COLORADO
Division of Water Resources
Department of Natural Resources

**Re: City of Fort Collins East Rigden Pit Substitute Water Supply Plan
(WDID 0302570, Plan ID 3055)
DRMS File No. M-1979-097 (WDID 0303021)
Section 28, T7N, R68W, 6th P.M.
Water Division 1, Water District 3, Larimer County**

Approval Period: July 1, 2019 through June 30, 2020
Contact information for Mr. Shuler: 303-806-8952; jshuler@bbawater.com

Figure 1
East Rigden Pit
Pre-1981 and
Expanded Pond Extents

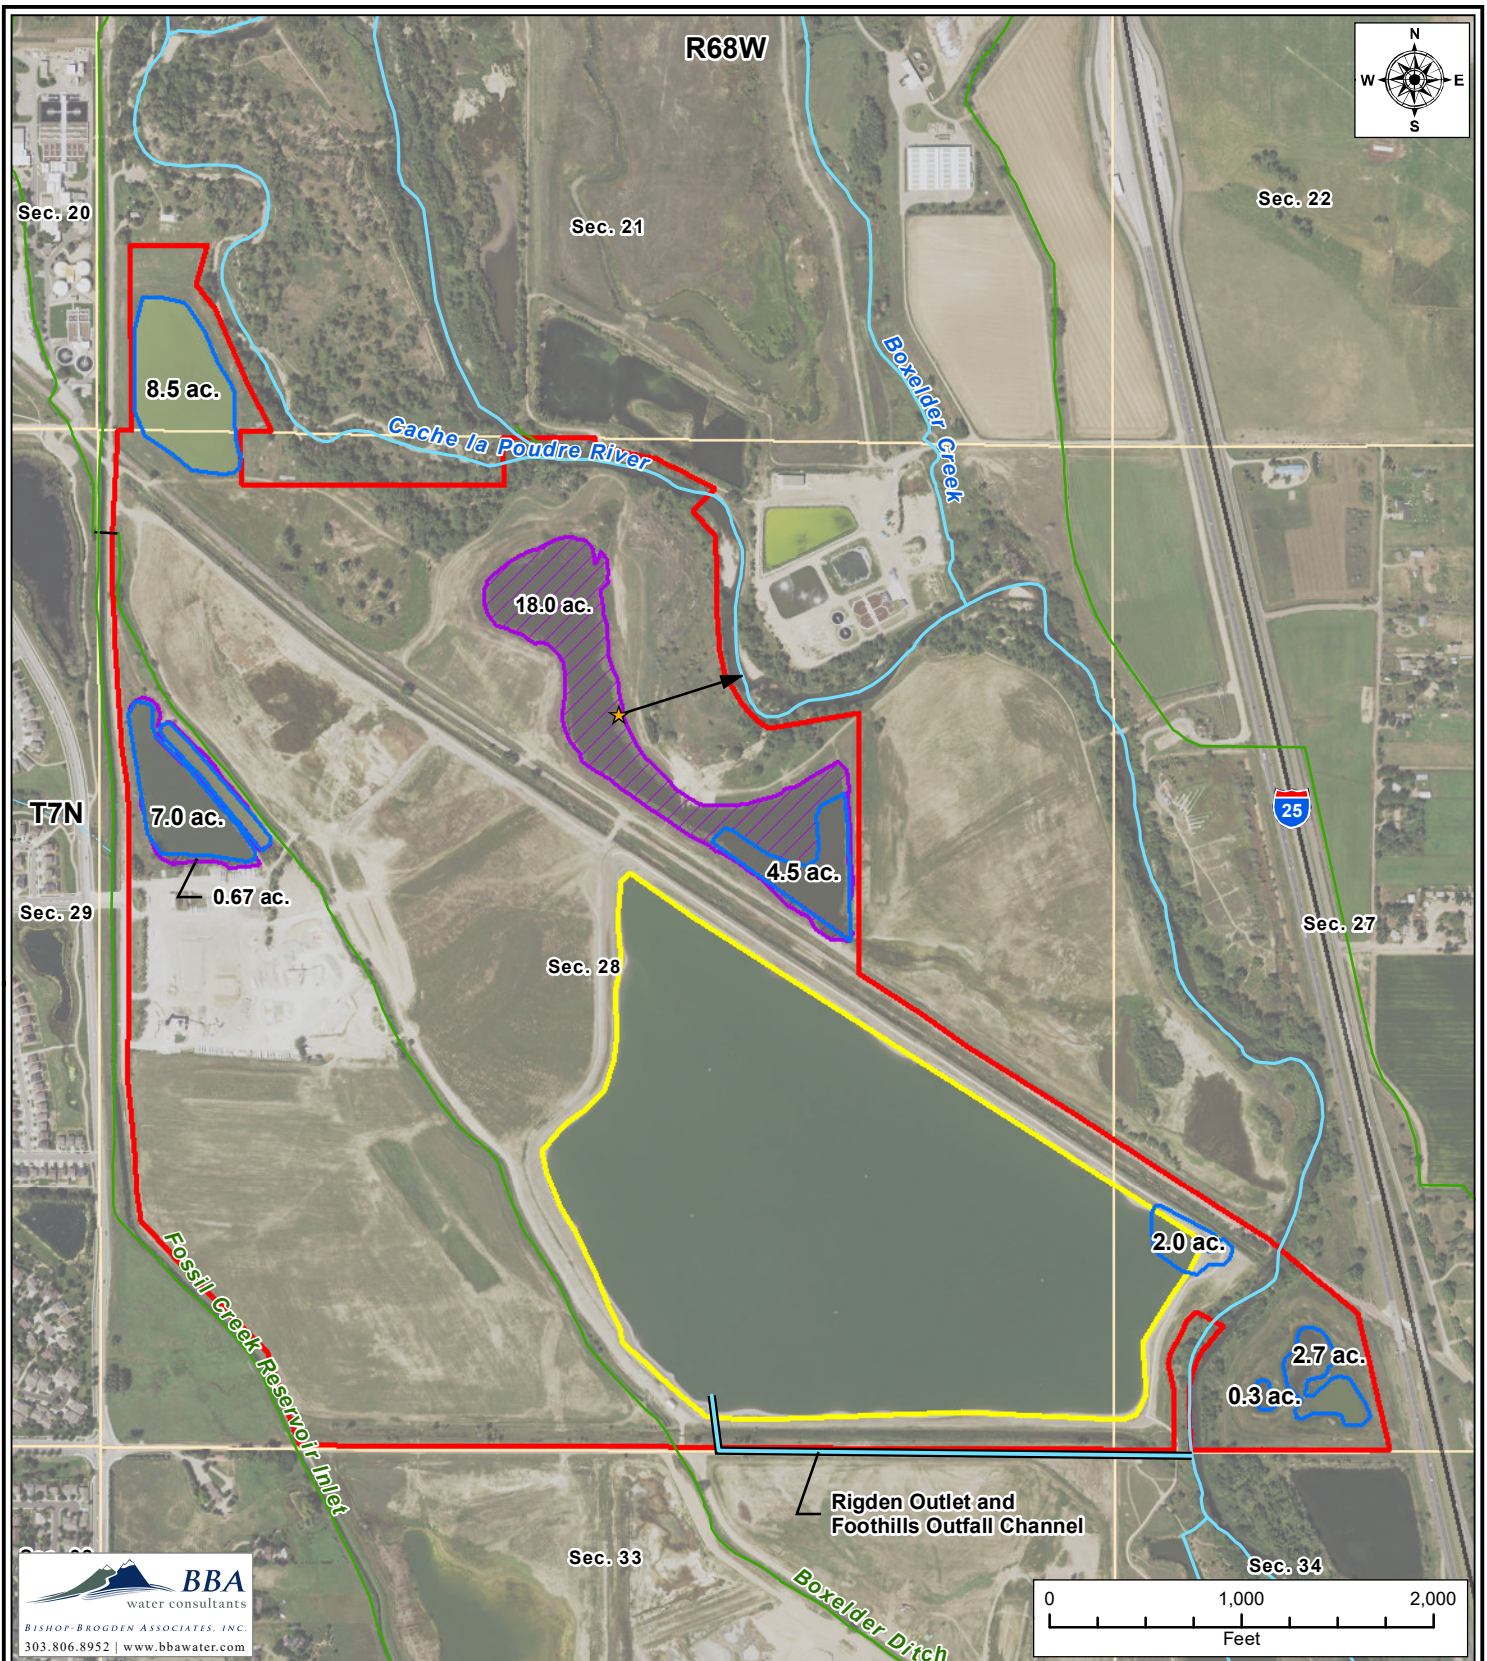
The East Rigden Pit is located along the Cache la Poudre River in Sections 21, 27, and 28, Township 7 North, Range 68 West of the 6th P.M. as shown on the attached Figure 1. Sand and gravel mining exposed groundwater at the pit site but the area has not been mined in many years according to a January 2019 inspection report from the Division of Reclamation, Mining and Safety ("DRMS"). The 2015-2016 SWSP determined that all 25 acres of groundwater exposed at that time were documented as having been exposed at the site prior to January 1, 1981. Pursuant to § 37-90-137(11)(b), C.R.S. and 2009CW49, a gravel pit operator or property owner does not need to replace depletions that occur due to evaporation from groundwater exposed prior to January 1, 1981 ("pre-81") as a result of open mining of sand and gravel, regardless of whether mining continued after December 31, 1980 ("post-80"). The pre-81 pond extents approved in the 2015-2016 East Rigden SWSP are shown in Figure 1, and may not be re-allocated to other areas of groundwater exposure within the gravel pit boundary. The 2015-2016 SWSP stated that with the SEO approval of the compacted clay liner in the Fort Collins Parcel, no depletions associated with the East Rigden Pit will remain after the conclusion of that plan period and no subsequent SWSP will be required for the site. However, a DRMS field inspection in January 2019 found that the acreage of the exposed groundwater had increased beyond the pre-81 extent. Fort Collins does not plan to conduct any mining activities during the term of this SWSP, therefore the only consumptive use of water at the East Rigden Pit will consist of evaporation from exposed groundwater.

DRMS estimated the areas of the post-80 exposed groundwater of the north, west, and northwest ponds to have expanded by 18, 0.67, and 0.38 acres respectively. DRMS estimated the acreage of the southeast pond to have decreased by 0.08 acres, however this decrease does not provide credit that can be allocated elsewhere. The Applicant agrees with the new acreage for the north and west ponds, but believes that the northwest and southeast ponds have maintained the extent of their approved pre-81 areas. The Applicant attributes the minor differences in surface area between that determined by DRMS and the prior mapping by Applegate to mapping accuracy discrepancies. This office conducted an analysis of currently exposed areas shown on aerial imagery and concurs that the minor differences in surface area could be attributed to mapping accuracy discrepancies and accepts the Applicant's proposal to maintain the extents of the area of the northwest and southeast ponds as were approved in the 2015-2016 SWSP.

3. The total surface area of the post-81 groundwater exposed at the East Rigden Pit site must not exceed 18.67 acres, which results in an annual net evaporative loss of 41.52 acre-feet.
